Field Report

The Park Danforth **Project No:** 13-059-00
Portland ME **Field Report No:** 22

To: Mark Donovan **Time of Visit:** 8:00 AM
 PC Construction **Date of Visit:** 10/25/2016
 131 Presumpscot Street **Weather:** Sunny, Cool (40 Degrees)
 Portland ME

Flooring protection in typical bathroom

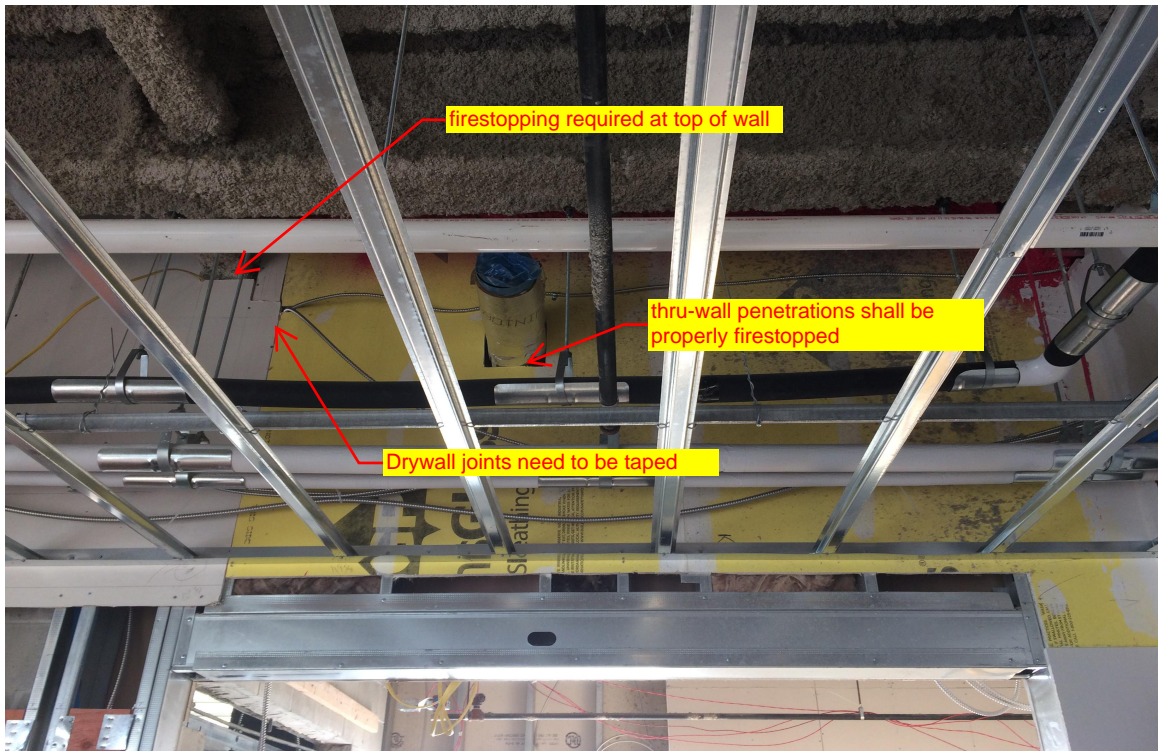
22.2	<p><u>Finish Flooring Protection</u></p> <p>Continue to protect carpeting and vinyl flooring in accordance with the Project Specifications. See attached Photos</p>	<div style="border: 1px solid black; padding: 5px; width: fit-content; margin: auto;">Correct Work</div>

Level 5 Community Room above the room's entrance. Reference Item #22.4

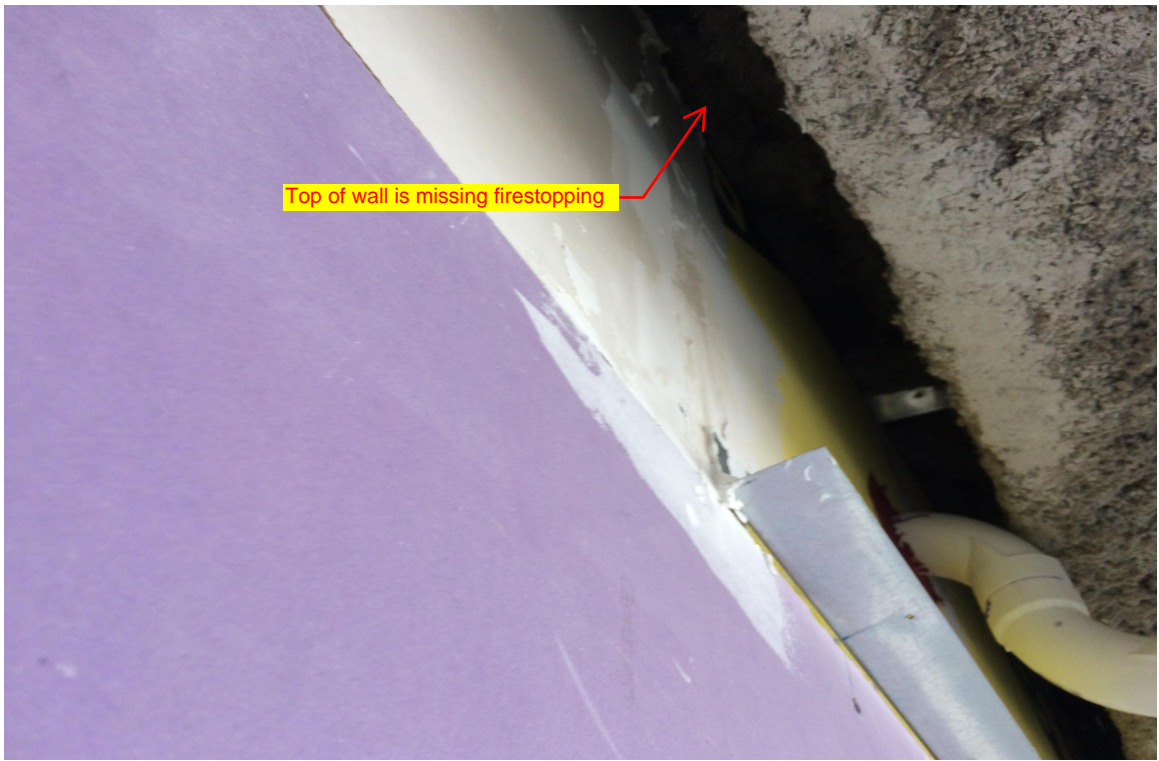
22.4	<p>Level 5 Community Room (5004)</p> <p>All above-ceiling drywall joints along the entry (rated) wall shall be taped per the partitions UL designation. All thru wall penetrations shall be properly fire sealed. See attached Photo.</p>	Correct Work

Group Room (4004) top of wall between group room and toilet rooms. Reference Item #22.5

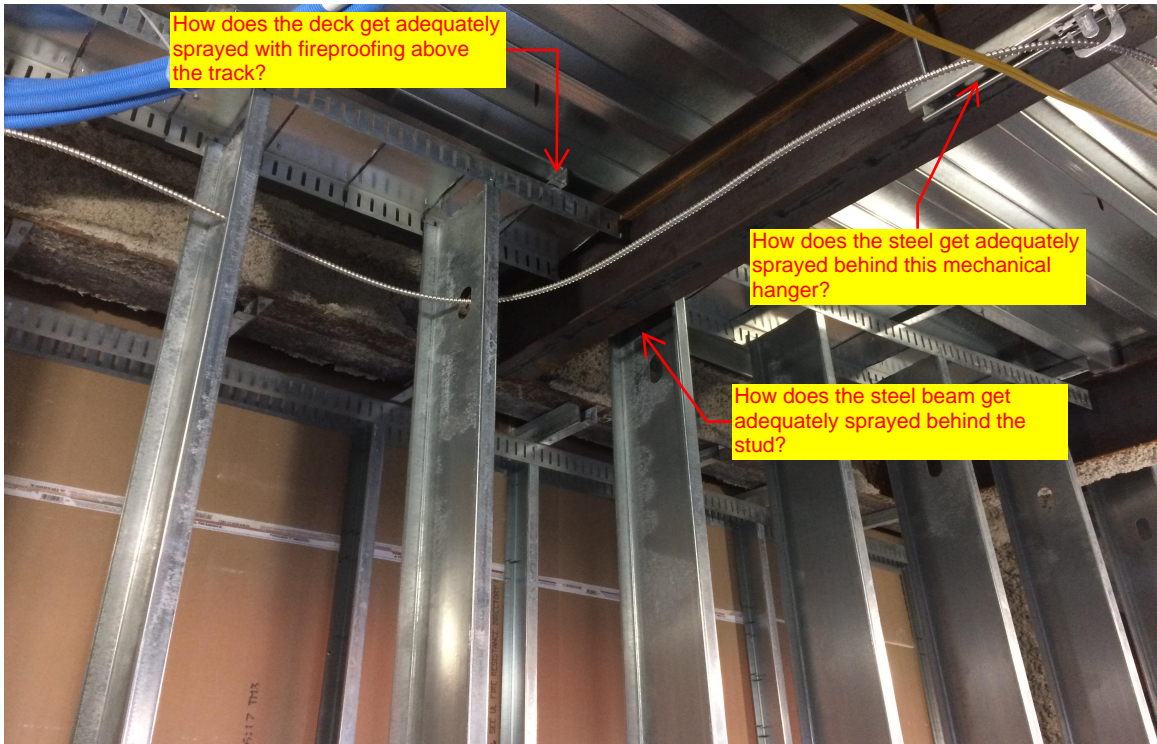
22.5	<p>Level 4 Group Room (4004)</p> <p>The wall that separates the Group Room from the toilet rooms/ante room is missing firestopping along the top of the wall. The drywall joint at the ceiling line also needs to be taped in accordance with it's UL design.</p> <p>Additionally, the column near door 4004 needs its spray fireproofing touched up prior to concealment in the wall.</p> <p>See attached photos.</p>	Correct Work
